LAKE NONA TOWN CENTER PHASE 2A AMENDMENT AND BIKE PLAN

SUMMARY

<p>Owner LN Towncenter II, LLC</p> <p>Applicant Heather Isaacs Tavistock Development Company</p> <p>Project Planner Wes Shaffer, Planner II</p> <p>Updated: May 7, 2018</p>	<p>Property Location: South of the Central Florida Greenway (SR 417), northwest of Lake Nona Boulevard, east of Boggy Creek Road (+/- 67.7 acres, District 1)</p> <p>Applicant's Request: Amend the Lake Nona Town Center Phase 2A SPMP to increase the development program from 1.24 million square feet of non-residential floor area and 200 hotel rooms on 49.75 acres of area to 1.33 million square feet of non-residential floor area and 215 hotel rooms on 56.77 acres of area. This request also includes a bike parking plan.</p> <p>Staff's Recommendation: Approval subject to the conditions of this report</p>
---	--

TOWN CENTER PHASE 2A - MASTER LEASE PLAN 12/18/17 (new future power center configuration)

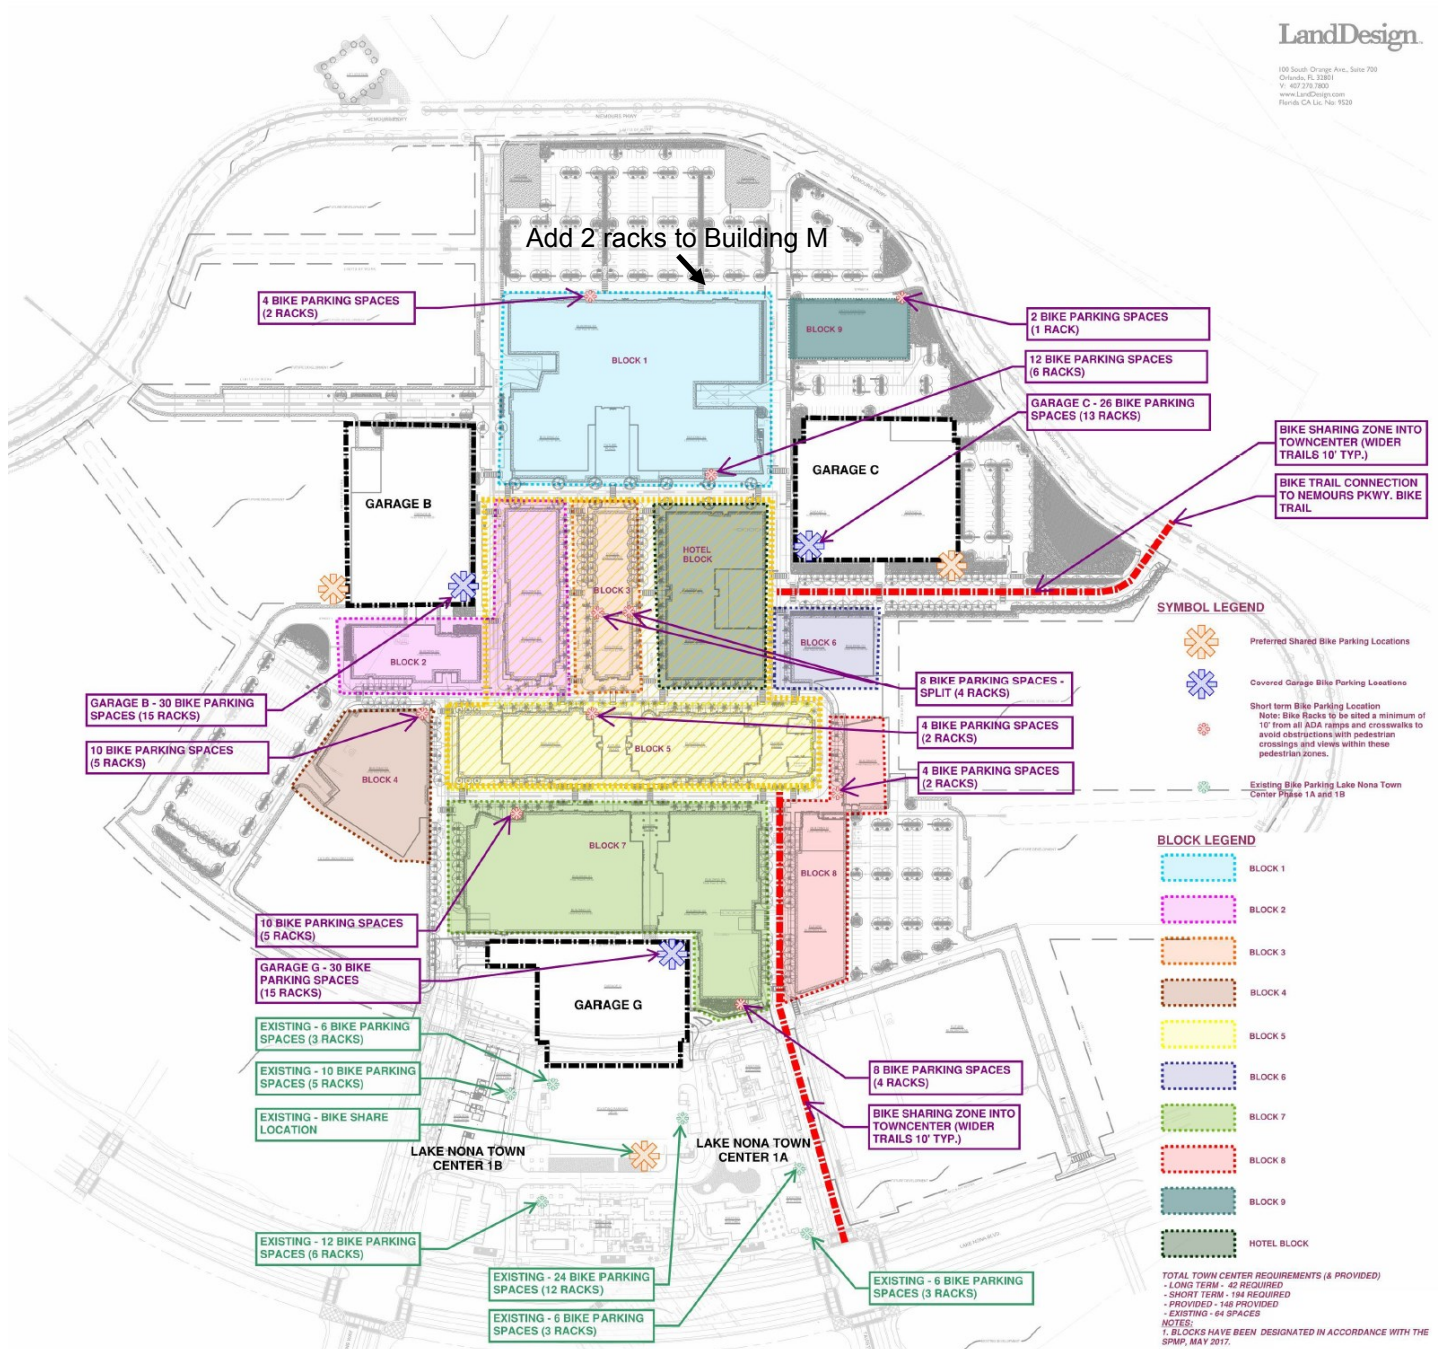
3. *ADDITIONAL BICYCLE PARKING*

Add 2 additional bicycle racks onto the “north” side of Block 1 (see **Page 11**).
